**ADDENDUM NUMBER TWO
FOR
Phase I Site Access Road & Utilities and
Phase II Library Building & Site Bid
IFB #2914/120700
LAI Project Number: 09107**

PREPARED BY:
Watson Tate Savory Liollo Architecture
147 Wappoo Creek Drive, Suite 400
Charleston, South Carolina 29412
(843) 762-2222

DATE OF ISSUE: July 6, 2011

S210 - LOW ROOF FRAMING PLAN REVISIONS

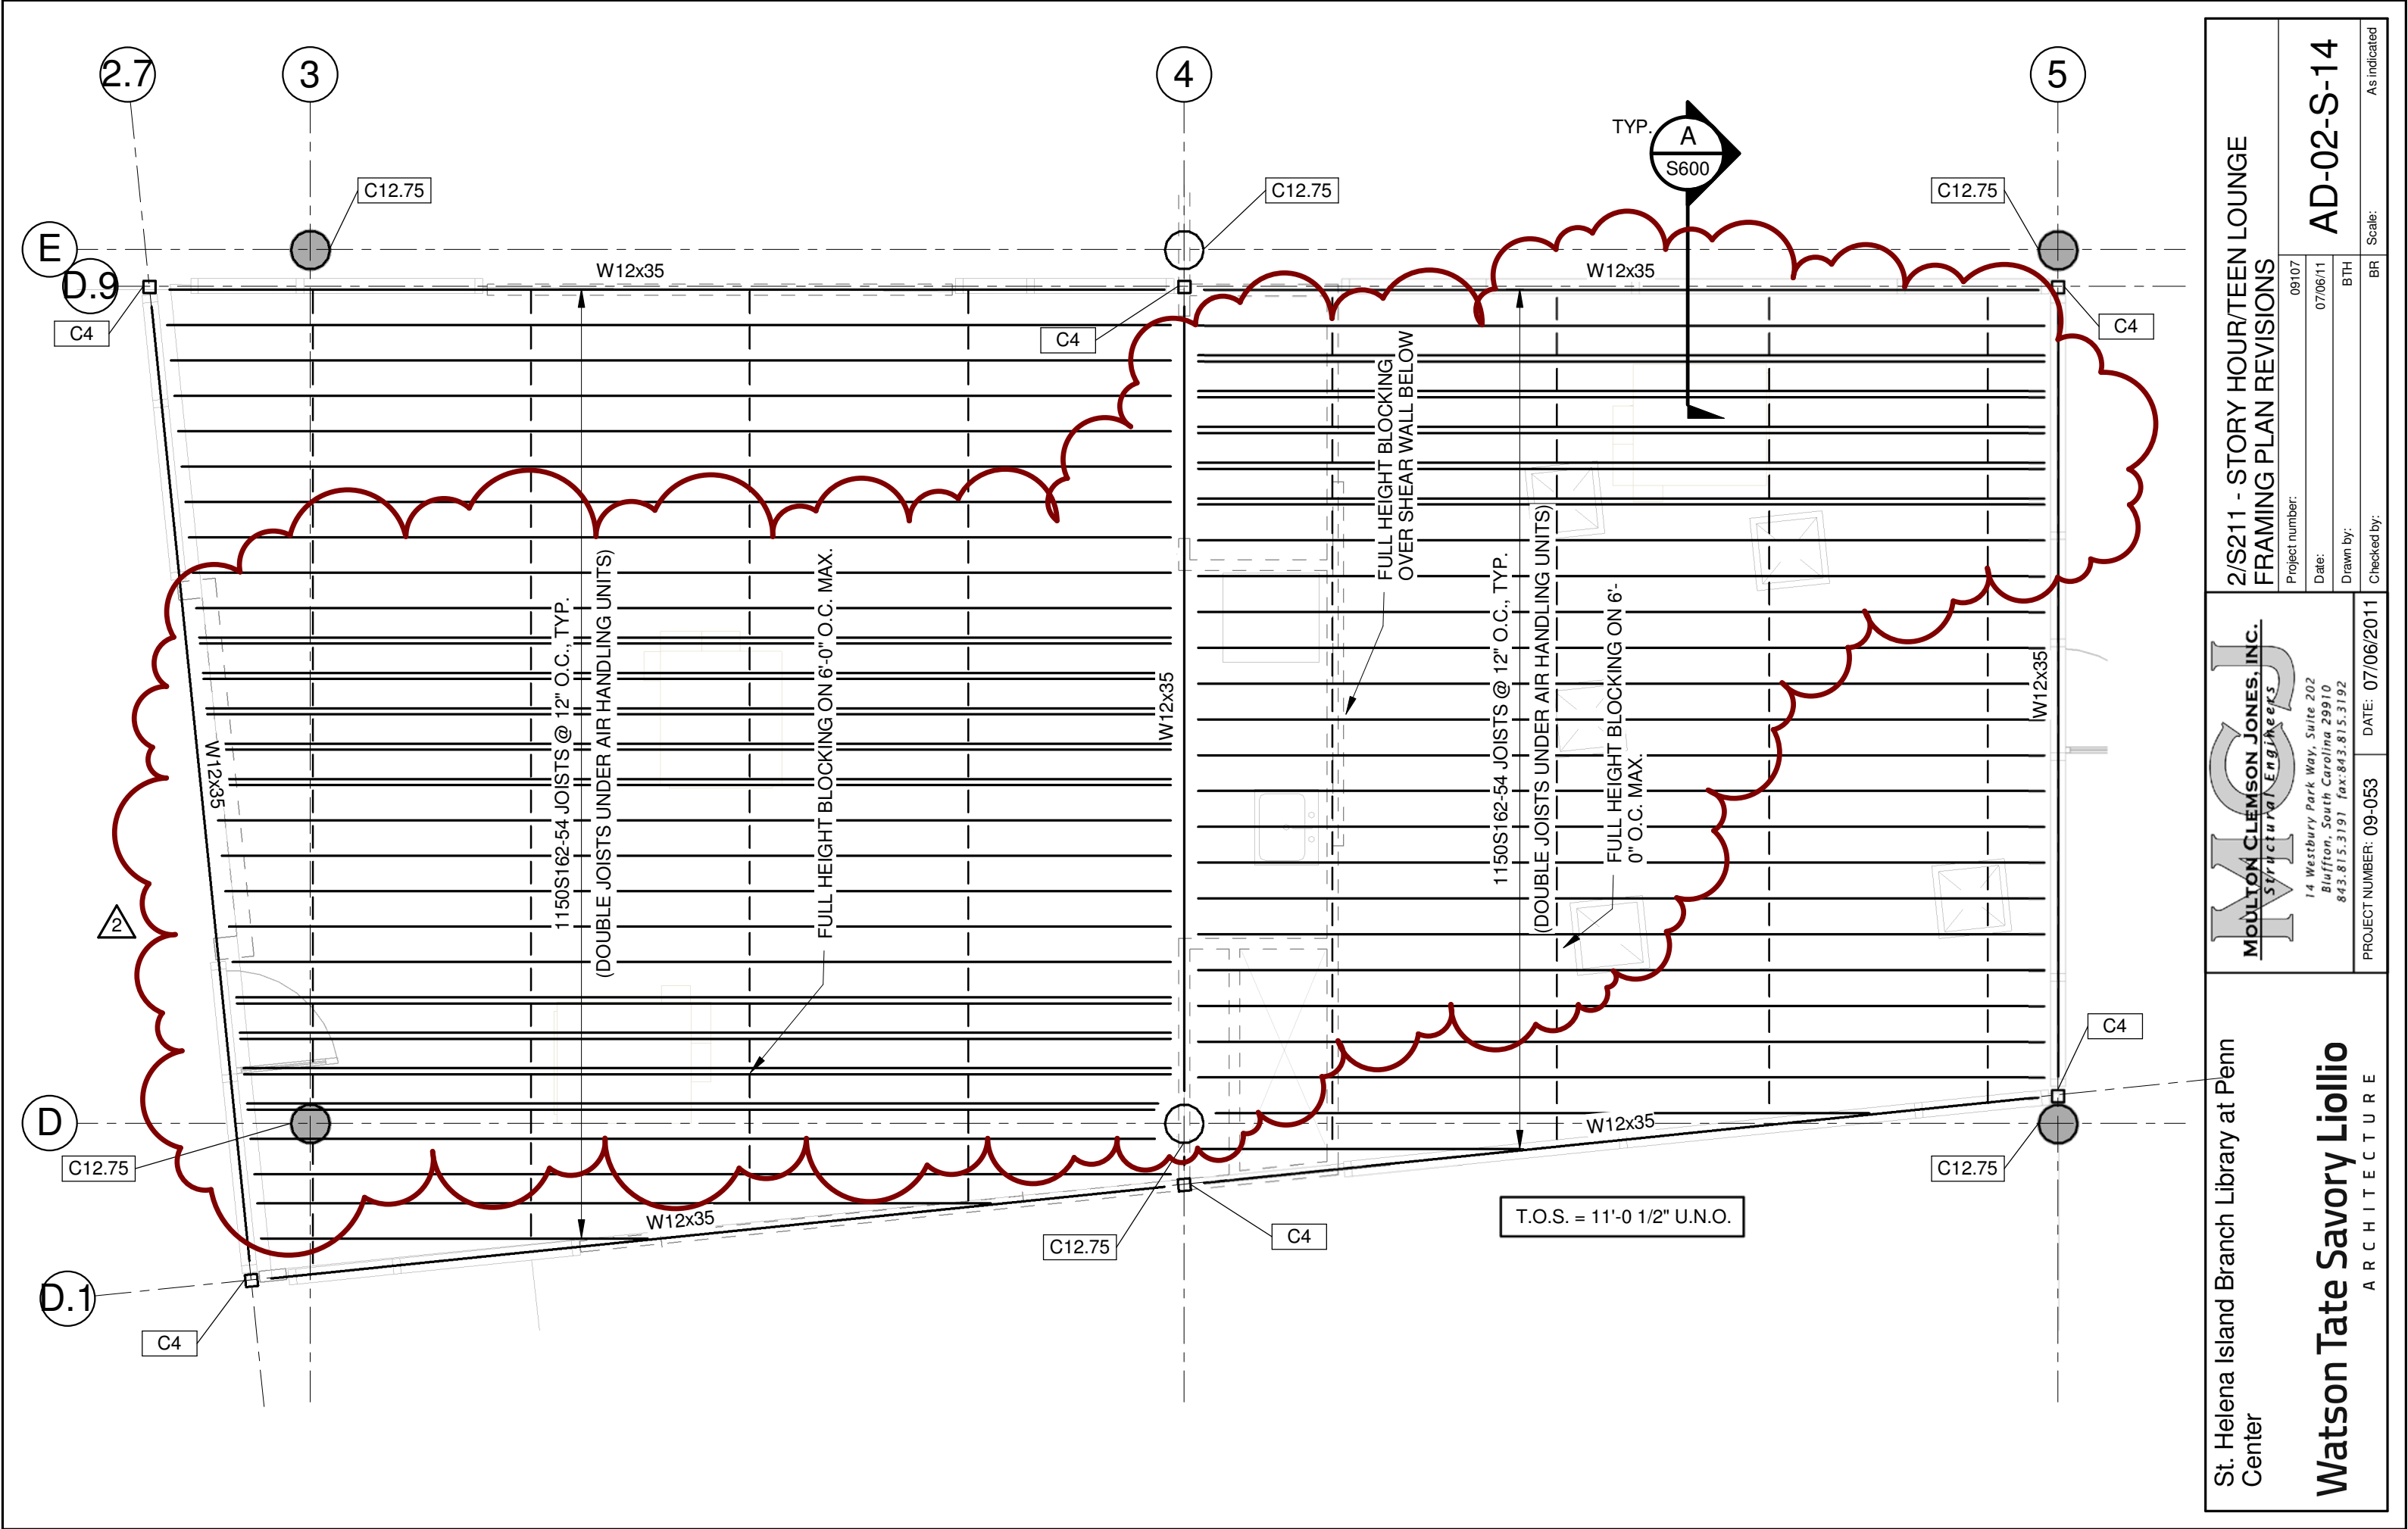
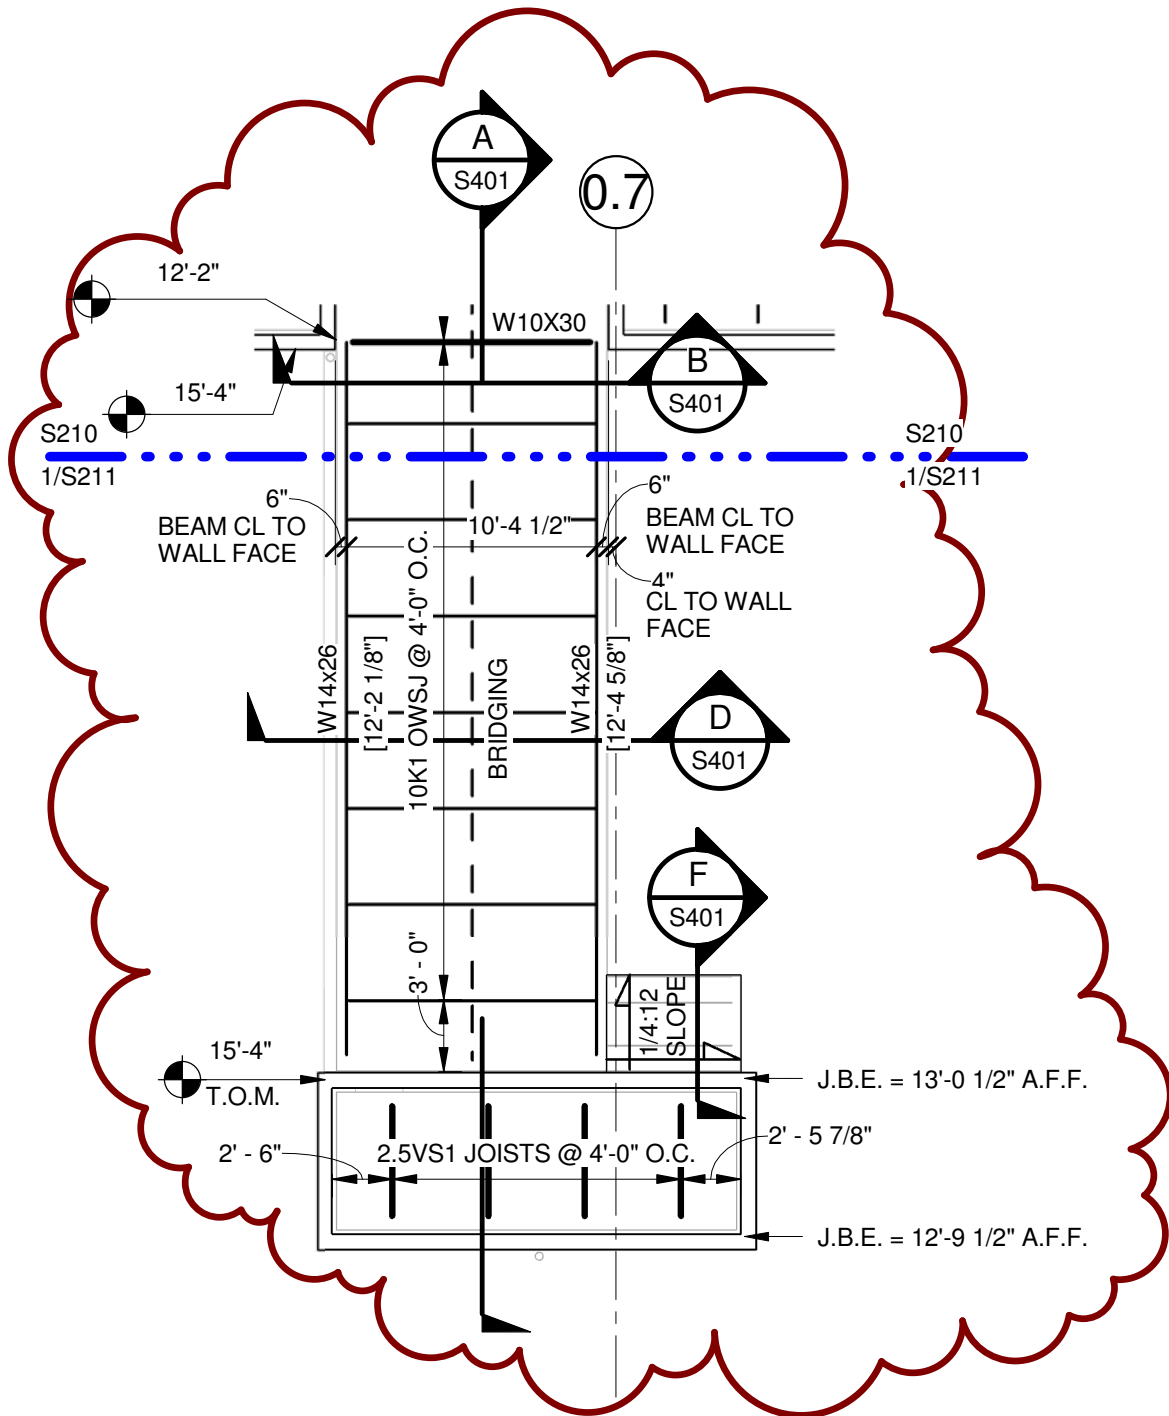
17. **Question:** Detail A/S402 refers to architectural for top of masonry. What is the top of masonry for detail 2/A502?
Answer: Top of masonry now called out on plan and in detail. See attached Sketches AD-02-S-12 and AD-02-S-13.

9. DRAWING S210: Refer to attached Sketches AD0-02-S-12 and AD0-02-S-13.
10. DRAWING S211: Refer to attached Sketches AD0-02-S-14 and AD0-02-S-15.
11. DRAWING S220: Refer to attached Sketch AD0-02-S-16.

A/S301 - PORCH SECTION w/ STAIR REVISIONS

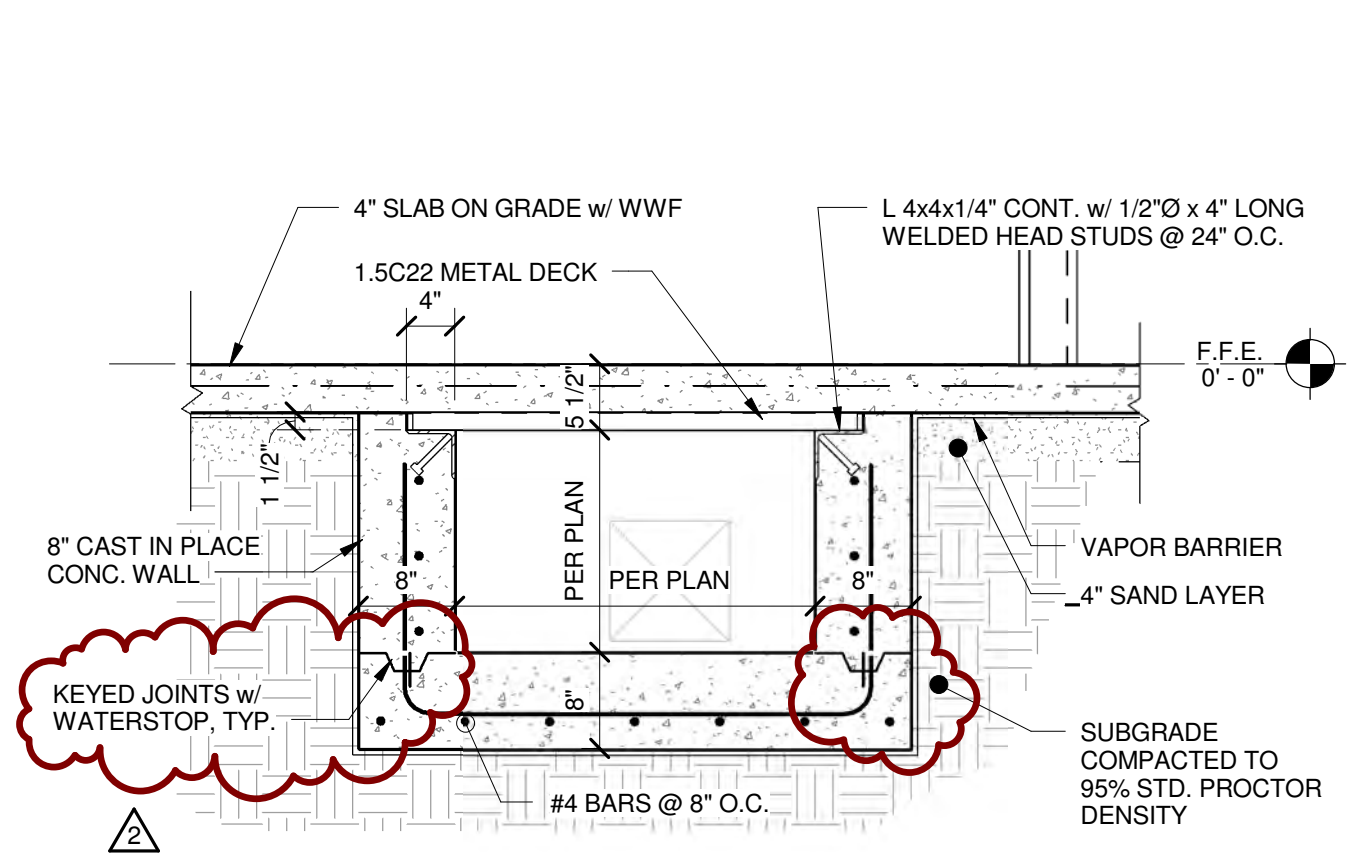
12. DRAWING S300: Refer to attached Sketches AD0-02-S-17 and AD0-02-S-18.
13. DRAWING S301: Refer to attached Sketches AD0-02-S-17, AD0-02-S-19, AD0-02-S-20, and AD0-02-S-21.

CMU WALL CONTROL JOINT

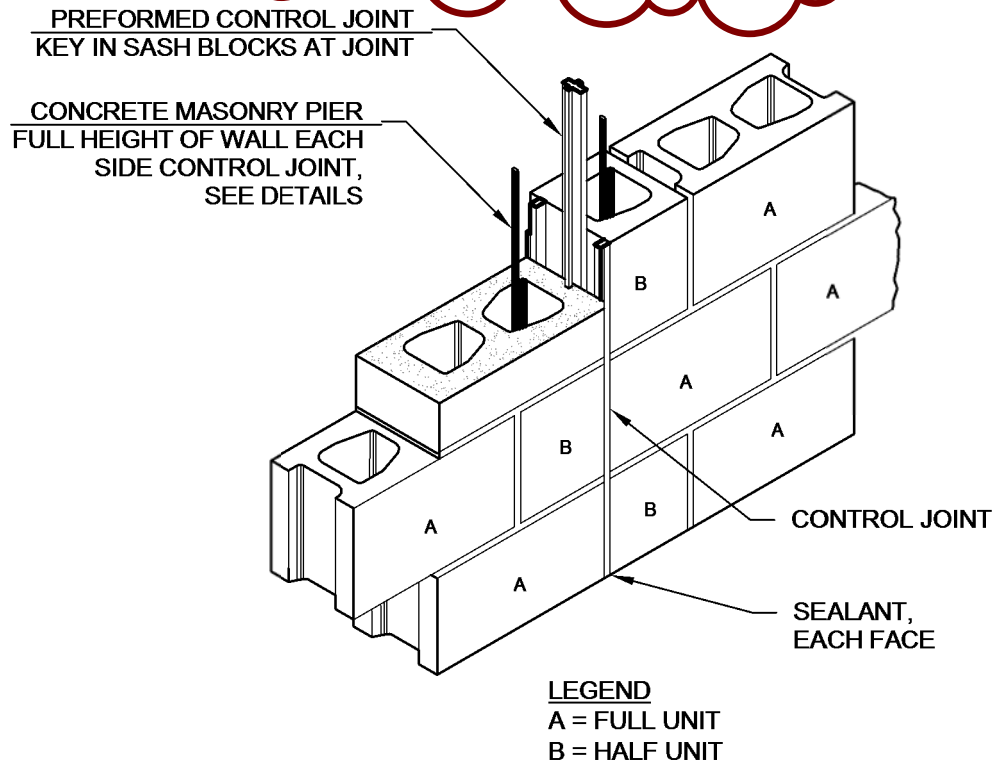
14. DRAWING S302: Refer to attached Sketches AD0-02-S-22, AD0-02-S-23, and AD0-02-S-24.
15. DRAWING S400: Refer to attached Sketches AD0-02-S-25 and AD0-02-S-26.
